PROPOSED PROJECT FOR

WIDRICK RESIDENCE

13402 TALBOT RD

**PLOT PLAN**

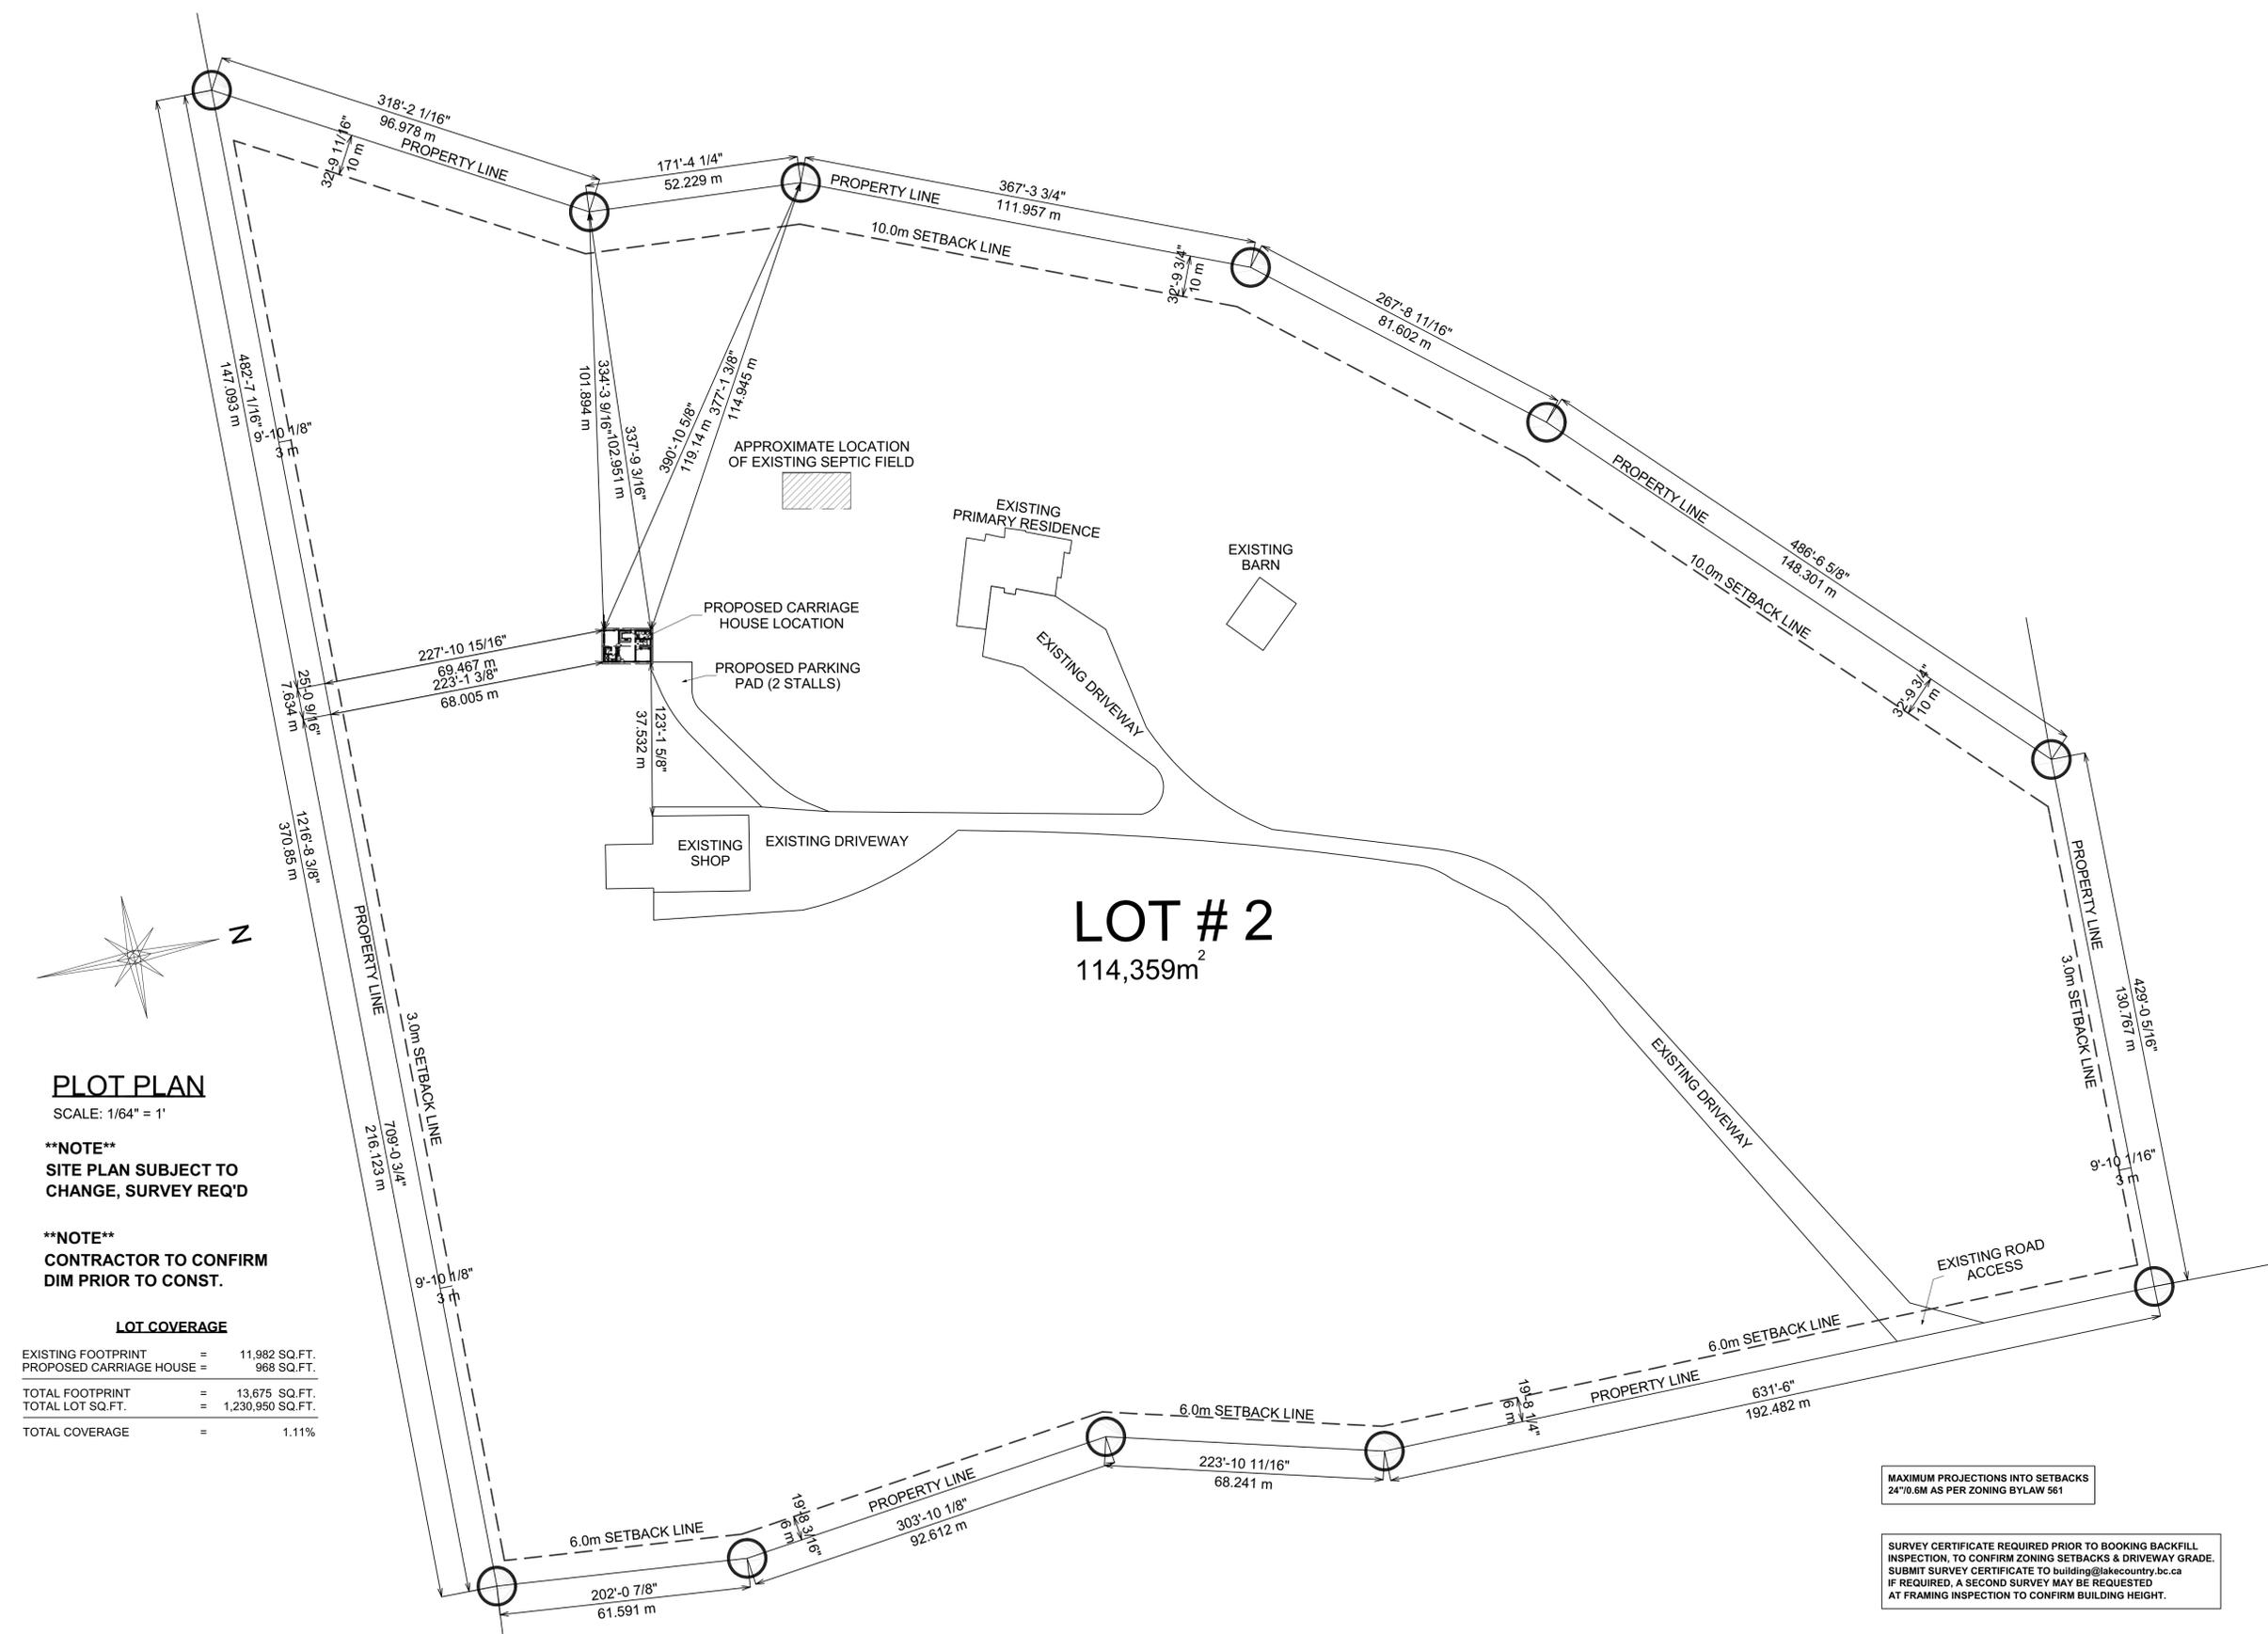
NOTE: APPROVAL FOR OCCUPANCY CANNOT BE ISSUED UNTIL SAFETY AND ENERGY PERFORMANCE ASPECTS(EXTERIOR SIDING) OF THE BUILDING HAVE BEEN COMPLETED

DISTRICT OF LAKE COUNTRY IS NOT RESPONSIBLE FOR THE USE AND PLACEMENT OF HOT TUBS. THE STRUCTURE MUST BE DESIGNED TO SUPPORT 130-150LBS PER SQ FT.

THE HOMEOWNER/BUILDER IS RESPONSIBLE TO ENSURE THE FOLLOWING IS ON SITE FOR REVIEWING BY THE BUILDING OFFICIAL FOR THE FRAMING INSPECTION:  
 - LAYOUT AND ENGINEER SEALED TRUSS SPECIFICATIONS  
 - LAYOUT AND ENGINEER SEALED BEAM SPECIFICATIONS  
 - HEADER DETAIL  
 - STRUCTURAL ENGINEERS FIELD REPORT (WHERE REQUIRED)

IF DOCUMENTS LISTED ABOVE ARE NOT ON SITE AT THE TIME OF FRAMING INSPECTION, A NEW INSPECTION WILL BE REQUIRED & MAY RESULT IN A RE-INSPECTION FEE

WINDOW WELLS SHALL HAVE A MINIMUM CLEARANCE OF 760MM, 30 INCHES 9.9.10.1

TOPLESS GLASS GUARDS ARE TO BE ENGINEERED  
 REQUIREMENTS FOR ENGINEERED GUARDS ARE:  
 - SITE/JOB SPECIFIC MANUFACTURES INSTRUCTION(S) (COMPLETE WITH ENGINEER SEAL) AND  
 - SCHEDULE B FROM A STRUCTURAL P.ENG. PLUS FIELD REVIEW OF INSTALLATION  
 - BOTH ARE REQUIRED PRIOR TO OCCUPANCY

PROVIDE REQUIRED HANDRAIL ON STAIRS AS PER TABLE 9.8.7.1 BCBC 2012

MAXIMUM PROJECTIONS INTO SETBACKS  
24"0.6M AS PER ZONING BYLAW 561

SURVEY CERTIFICATE REQUIRED PRIOR TO BOOKING BACKFILL INSPECTION, TO CONFIRM ZONING SETBACKS & DRIVEWAY GRADE. SUBMIT SURVEY CERTIFICATE TO building@lakecountry.bc.ca IF REQUIRED, A SECOND SURVEY MAY BE REQUESTED AT FRAMING INSPECTION TO CONFIRM BUILDING HEIGHT.

ANY RETAINING WALL(S) GREATER THAN 1.22m (MEASURED FROM LOWEST GRADE) WILL REQUIRE A BUILDING PERMIT WITH A SCHEDULE B FROM AN ENGINEER (AS PER BUILDING BYLAW 1070)
